**AMENDMENT NO. 1 OCTOBER 2008
TO
IS 2556 (PART 4) : 2004 VITREOUS SANITARY
APPLIANCES (VITREOUS CHINA) — SPECIFICATION**

PART 4 SPECIFIC REQUIREMENTS OF WASH BASINS

(Fourth Revision)

FIG. 7 PEDESTAL FOR WASH BASIN

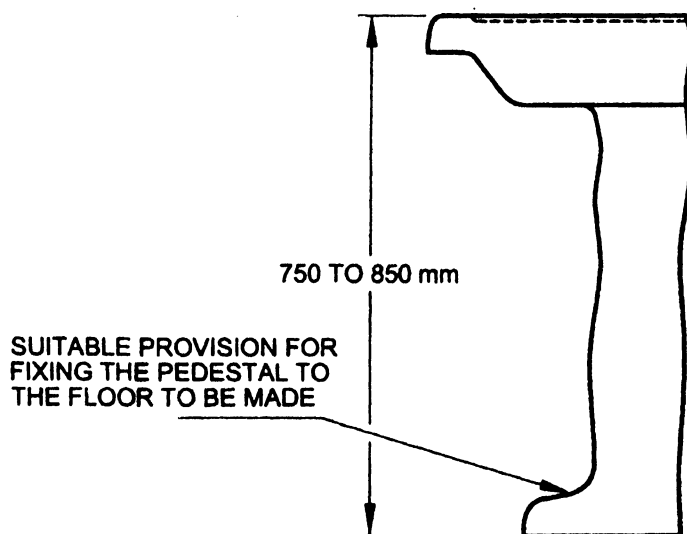
(Page 6, Fig 7) — Substitute the following for the existing figure:
